**Re: Ventana Ranch Community Park, Drainage Management Plan  
Engineer's Stamp Date 5/01/12 (B10/D003)**

Re: Ventana Ranch Community Park, Drainage Management Plan (B10/D003)

MASTER DEVELOPMENT PLAN  
DRAINAGE MANAGEMENT PLAN

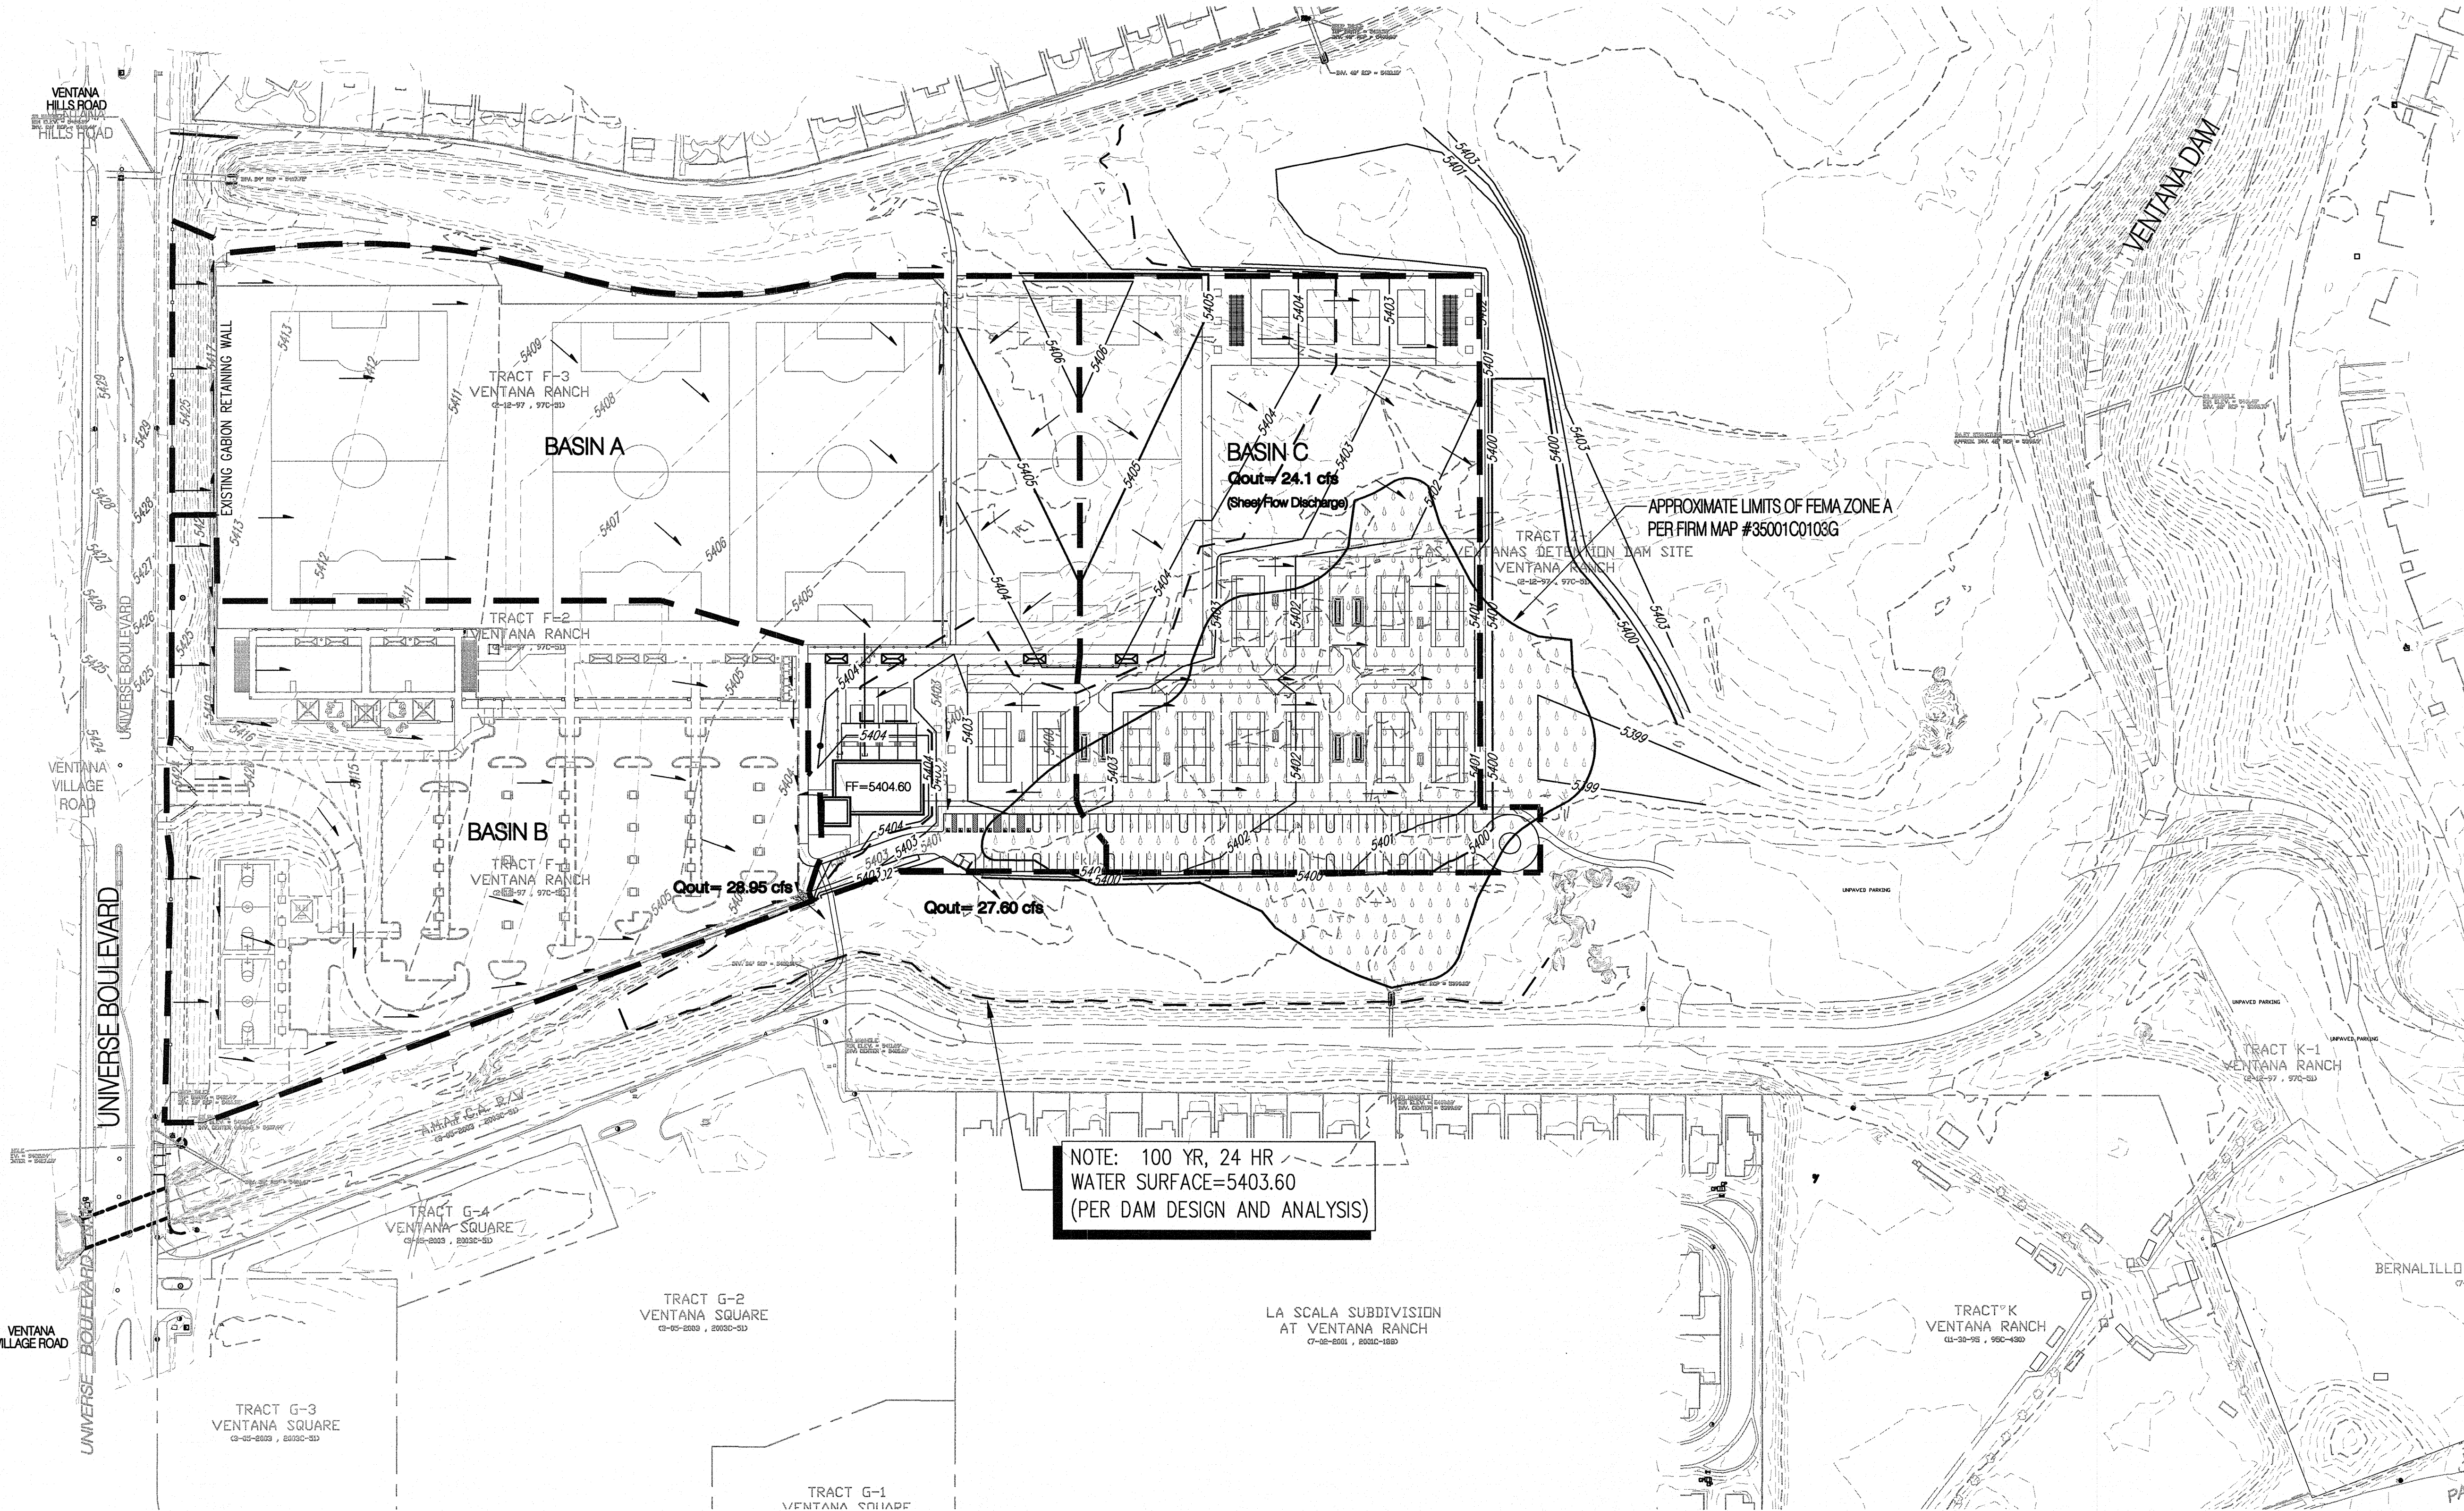
- AMAFCA approval is required.
  - Please see attached email from Lynn Mazur, dated 04/18/2012, for approval.
- Show the Zone A flood zone. The proposed building must be outside the limits of the flood zone or a LOMR will be required.
  - The flood zone approximate limits are shown on the plan per FIRM map #35001C0103G and the proposed building is not within the flood zone limits.
- Are the pedestrian crossings across the arroyos grade separated?
  - The pedestrian crossings are proposed to be at grade; Lynn Mazur verbally indicated that AMAFCA does not have problems with crusher fine paths crossing the arroyos at grade.
